Planning Board – August 28, 2017, 6:30PM
City Hall Council Chambers – 3 Washington Street, 2nd floor

**CITY OF KEENE
NEW HAMPSHIRE**

**PLANNING BOARD
MEETING MINUTES**

SPR-09-17 SITE PLAN REVIEW – 38 Roxbury Street, MoCo Arts Building

PROPOSED SITE
 PLAN

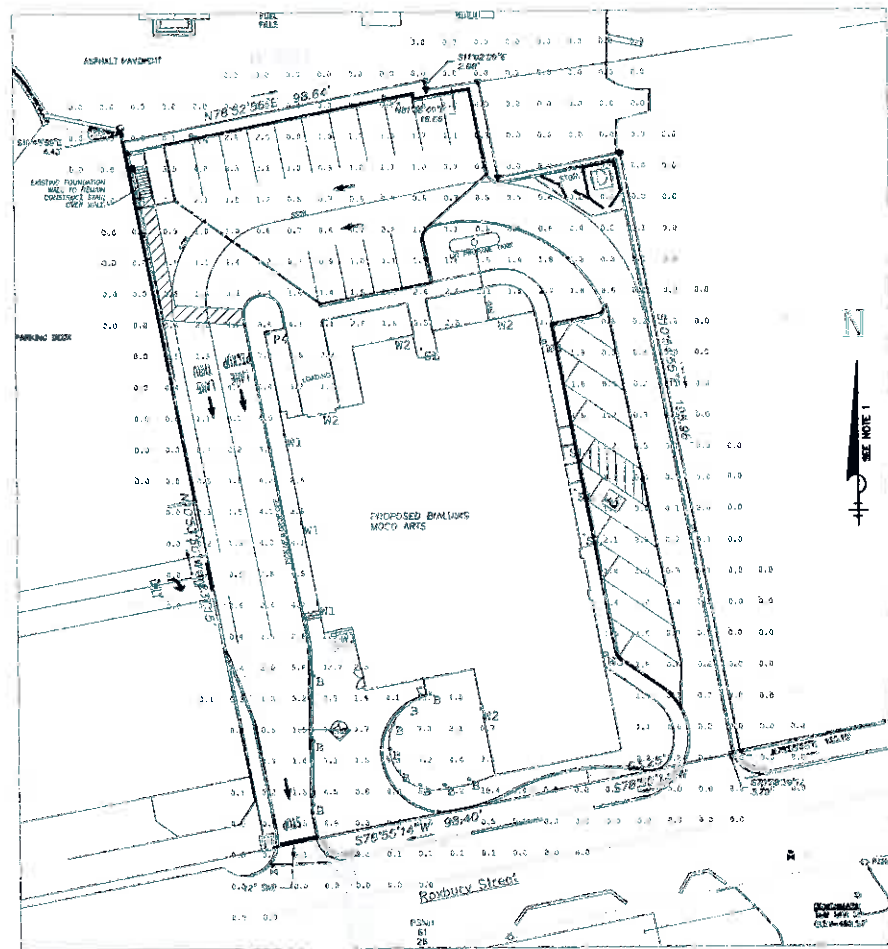
- C. This standard has been met.
13. Comprehensive Access Management:
- A. The handicapped-accessible parking space and accessible route is relocated to the east side of the building with revised grading. Correspondingly, the stop sign location at Roxbury Street is shifted.

- B. The brick benches are removed from the entry courtyard area.
 - C. The vertical granite curb is changed to a sloped granite curb along the front planter and courtyard area.

LIGHTING PLAN

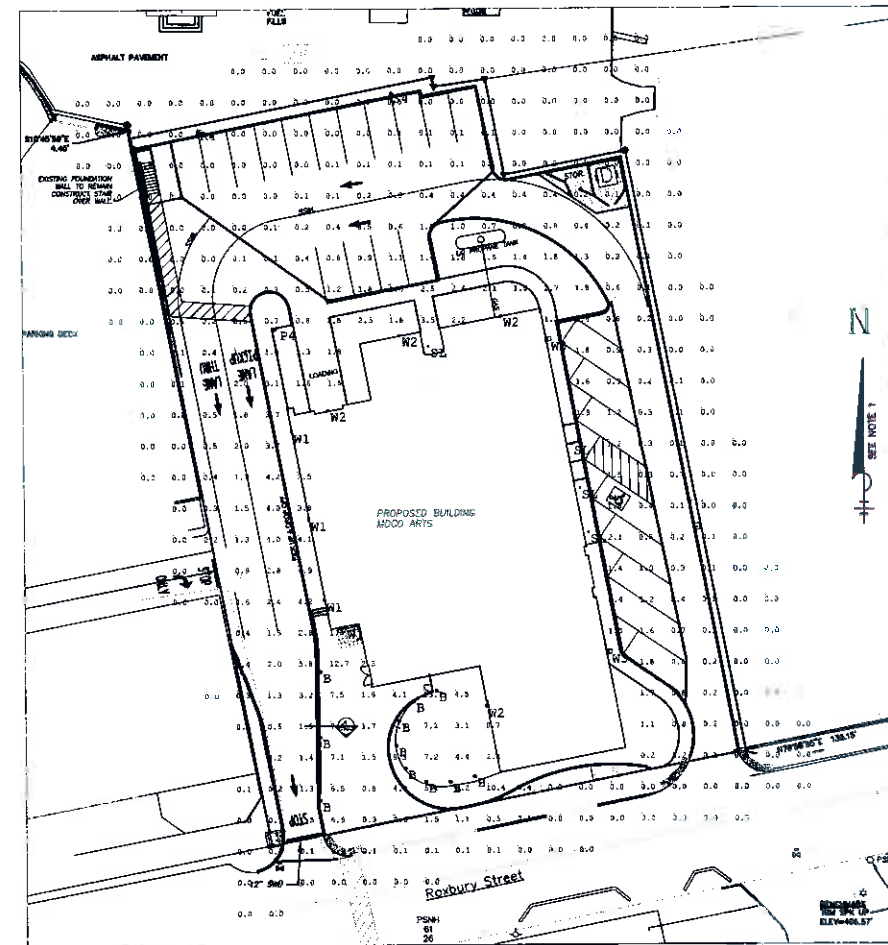
- A. The initial condition requiring additional lighting at the rear northwest corner of the building was remedied per a revised lighting plan submitted on August 4, 2016.

- B. One pole light was removed at the loading dock area, and three additional wall mounted lights were added per the revisions submitted April 4, 2017.

Michele, Attached is the revised lighting plan. We added another light pole at the rear northwest corner of the building. The minimum levels are now 0.7 fc at the crosswalk and over 1 fc on the stairs. Please replace this page in the signature sets and in the pdf set we sent to you earlier.

DUMPSTER ENCLOSURE DETAIL

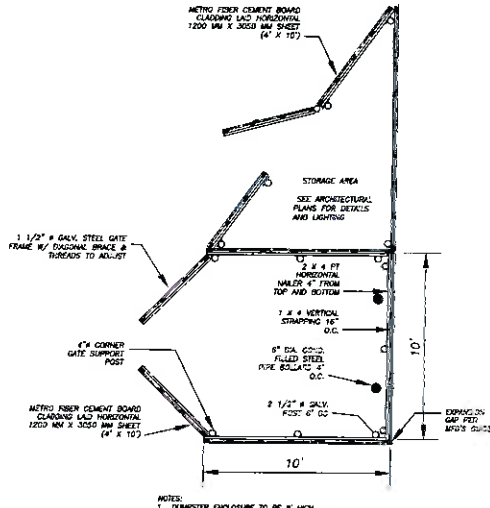
8. Screening: The screened dumpster enclosure's height is increased to 8-feet and enlarged to add a storage shed. This standard has been met.
10. Lighting:

Figure 2: Developable Areas in Green & Brown

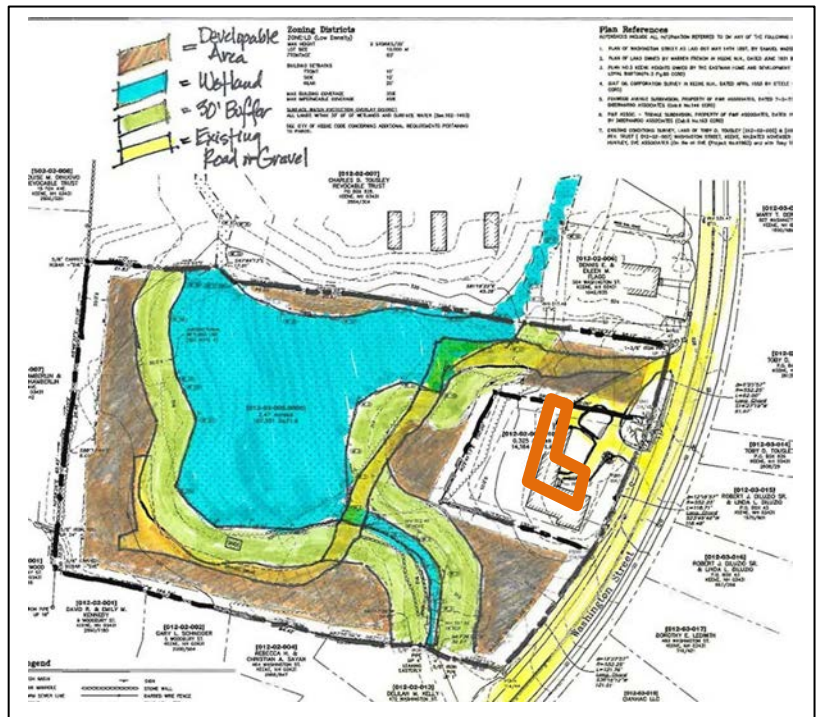
74,052 SF. The minimum lot area in the Low Density zoning district is 10,000 SF. Therefore the required minimum lot area is available. However, as shown in Figure 2, the developable areas are dispersed throughout the proposed, new parcel.

16. Wetlands: As shown in blue on Figure 2, the existing wetlands occupy the majority of the central and northern area of the proposed new parcel. Impacting the existing wetland with a proposed, future development would require a permit application with the Wetlands Bureau of the NH Department of Environmental Services (DES).

17. Surface Waters: The buffer areas of the proposed lot are highlighted in green on Figure 2. Per Sec. 102-1488, the City of Keene allows for the disturbance of the protective, wetland buffer for new structures, roads, driveways, stormwater management structures and compensatory flood storage through the approval of a Conditional Use Permit application. This type of request is approved only when all of the following criteria specified in Sec. 102-1490 have been met, as decided by the Planning Board:

Photo to the right: This photo is taken facing the southwest corner of the parking lot. The 4 new parking spaces are proposed to be located in front of the red storage structure.

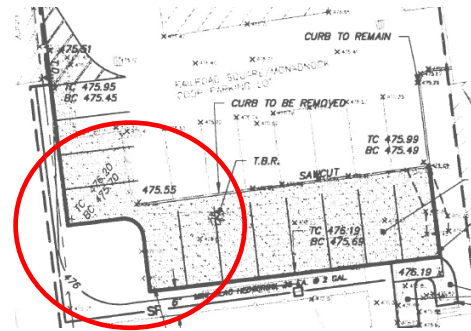
8. Screening: The four new parking spaces in the southwest corner of the lot will be screened by an existing structure on an adjacent property. The Applicant proposes to install a row of lilac shrubs between the row of 8 spaces at the southern end of the parking lot and the existing playground area. These shrubs will provide some screening of the vehicles from the playground area.
